CERTIFICATE OF OCCUPANCY Issued: 9/10/2020

Location:
100 Georgetown Road

Re: Drainage Analysis
100 Georgetown Road
Revised Parcel 475 A

Re: 100 Georgetown Road
Revised Parcel 475A
Construct Single Family Dwelling
Drainage Analysis

IMPROVEMENT LOCATION SURVEY
REVISED PARCEL 475A
100 GEORGETOWN ROAD
WESTON, CONNECTICUT

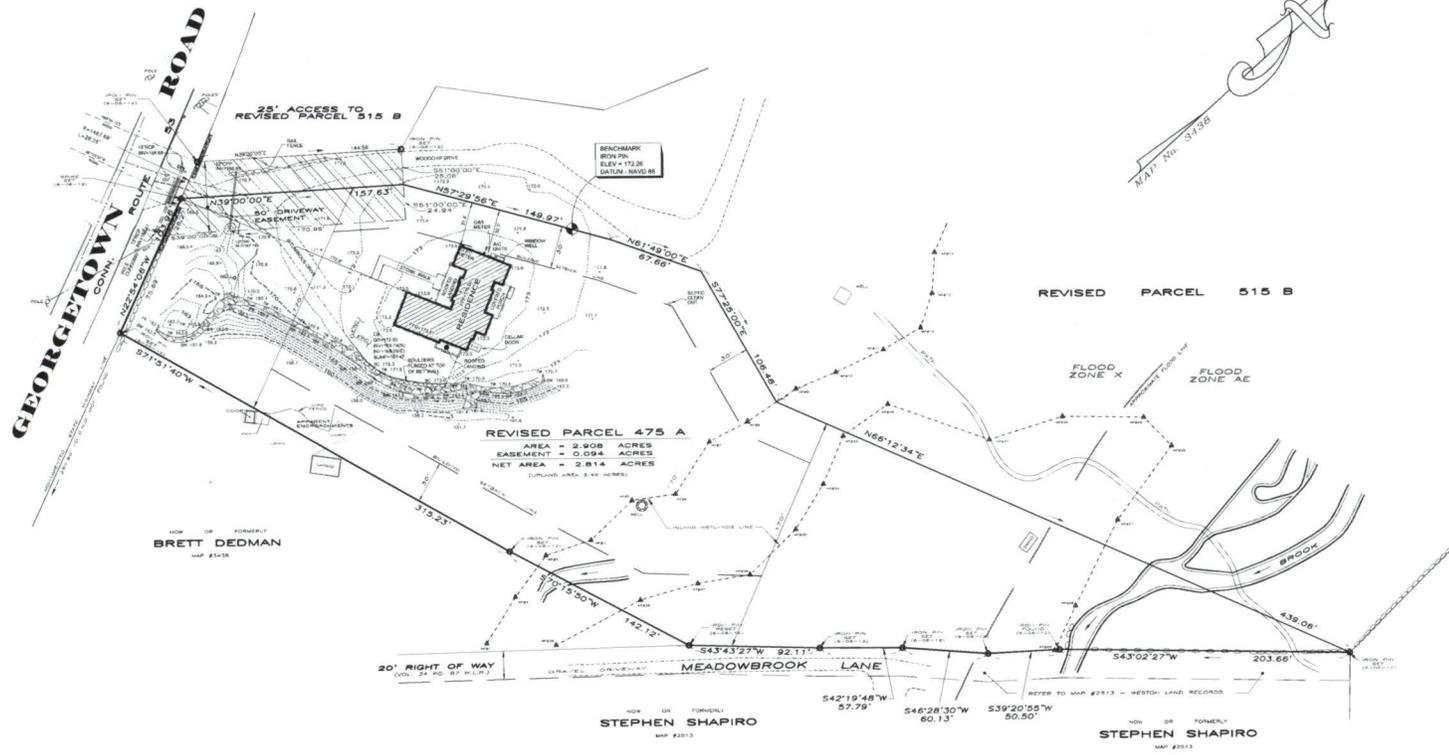
*** Peak Engineers, LLC has reviewed the "asbuilt" plan by Ryan and Faulds, Land Surveyors Wilton, CT, plan title "Improvement Location Survey, Revised Parcel 475A, 100 Georgetown Road, prepared for 100 Georgetown Road, LLC, Weston, Connecticut, dated June 8, 2020, revised September 2, 2020 and finds the following:

The building's first floor has been raised one foot above the elevation indicated on the approved plan. The garage lip is 1.6' above the elevation indicated on the approved plan. The builder has chosen to set the low spot of the driveway (catch basin) in a different location (to the west). These three modifications to the approved plan result in the edge of driveway opposite the garage being higher than indicated on the approved plan.

The vast majority of the site has mature grass. The erosion controls have been removed. The builder placed grass seed on the bolder/dirt slope. The grass is mostly taken hold and

is maturing. The builder has placed wood chips at the base of the wall to aid in prevention of erosion on this flatter slope.
